ADDENDUM

ITN NUMBER: 2021-25MCSA OPENING DATE & TIME: 7/15/22

ITN TITLE: MASTER CONTROL AND/OR TRAFFIC SERVICES

ADDENDUM NUMBER: 1 ADDENDUM DATE: 7/7/22

SHEET TITLE:
WUCF TV HIGH LEVEL

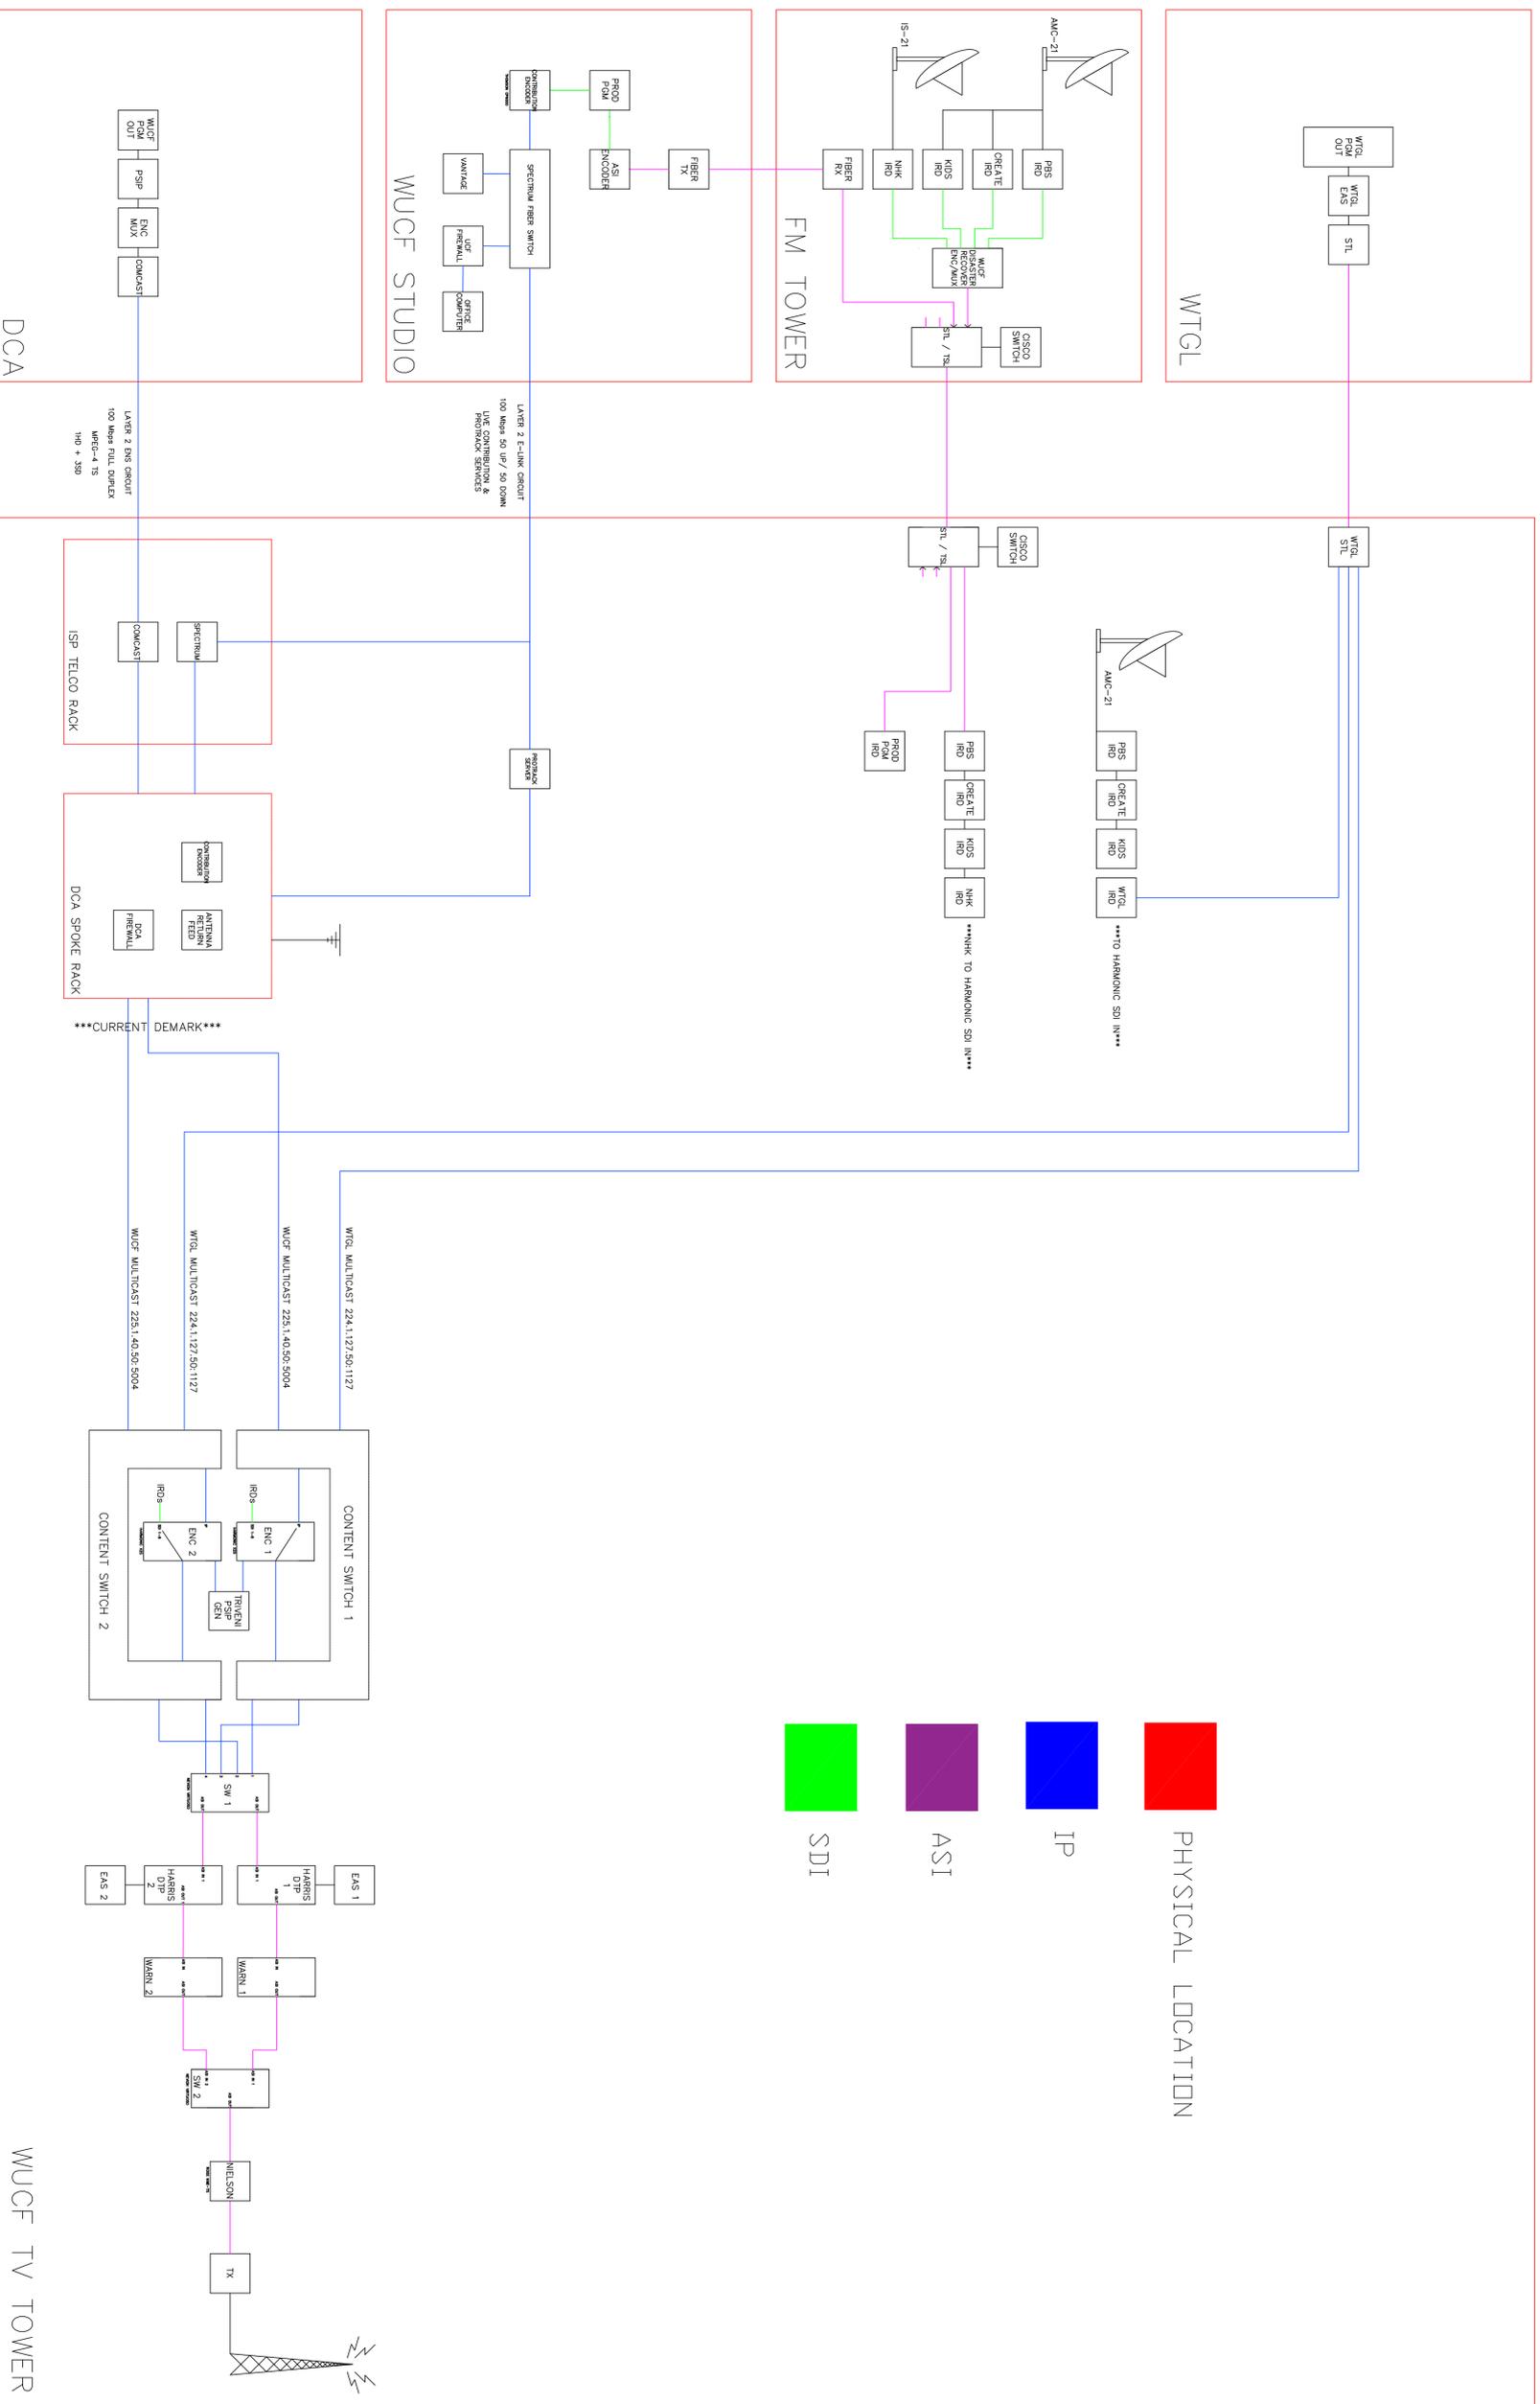
15. Vendor Question: Are drawings of existing audio/visual systems immediately available to prospective vendors as a reference for technical integration purposes.

UCF Answer: Yes, see drawings on pg. 5 of this addendum (below) followed by a "signal path narrative".
